SUBJECT: THREE MILE ISLAND, UNIT 1 - ISSUANCE OF AMENDMENT RE: REDUCING THE
TECHNICAL SPECIFICATIONS MAXIMUM ALLOWABLE DOSE EQUIVALENT
IODINE-131 LIMIT IN THE REACTOR PRIMARY COOLANT (TAC NO. M99399)

AMENDMENT NO. 204 TO FACILITY OPERATING LICENSE NO. DPR-50 THREE MILE ISLAND

SAFETY EVALUATION BY THE OFFICE OF NUCLEAR REACTOR REGULATION
RELATED TO AMENDMENT NO. 204 TO FACILITY OPERATING LICENSE NO. DPR-50

FIGURE 3.1-2a

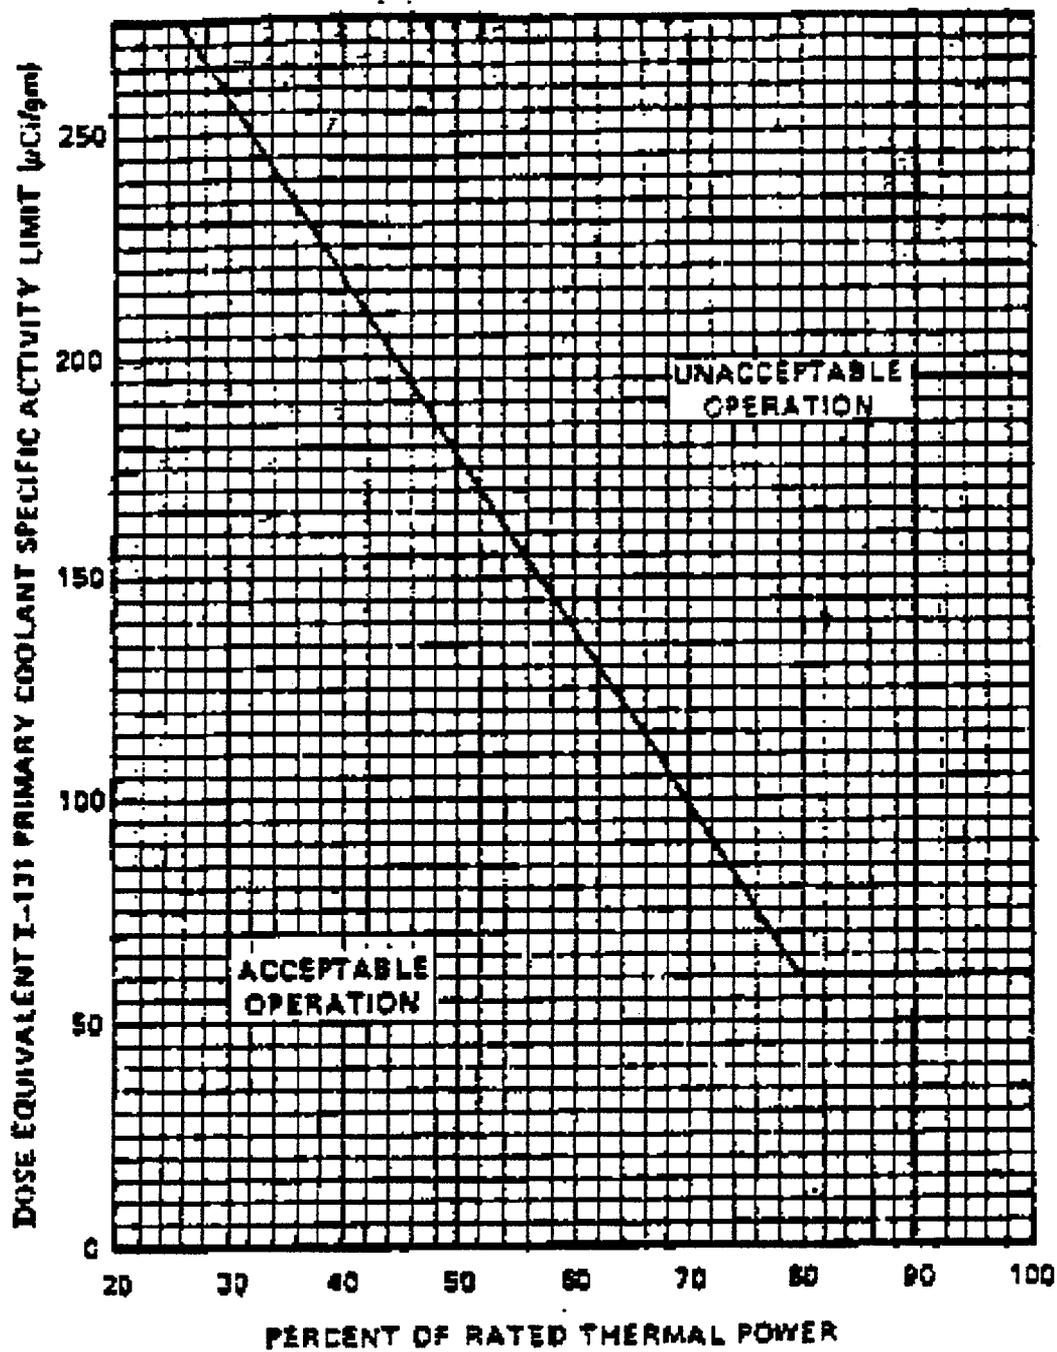
radiological consequence assessments meet the relevant dose acceptance criteria; however, the licensee proposed to change the maximum allowable dose equivalent iodine-131 limit in the reactor primary coolant to 0.35 $\mu\text{Ci/gm}$ from 1.0 $\mu\text{Ci/gm}$ in the TMI-1/TS Section 3.1.4 (and Fig. 3.1-2a) to address the staff's concerns discussed below.

- a. With the specific activity of the primary coolant greater than 0.35 microcurie/gram DOSE EQUIVALENT I-131 for more than 48 hours** during one continuous time interval or exceeding the limit line shown on Figure 3.1-2a, be in at least HOT SHUTDOWN within 6 hours. Power operation may continue when DOSE EQUIVALENT I-131 is below 0.35 microcurie/gram.
- b. With the specific activity of the primary coolant greater than $100/\bar{E}$ microcuries/gram be in at least HOT SHUTDOWN within 6 hours. Power operation may continue when primary coolant activity is less than $100/\bar{E}$ microcuries/gram.

The ACTION statement permitting POWER OPERATION to continue for limited time periods with the primary coolant's specific activity greater than 0.35 microcurie/gram DOSE EQUIVALENT I-131, but within the allowable limit shown on Figure 3.1-2a, accommodates possible iodine spiking phenomenon which may occur following changes in THERMAL POWER.
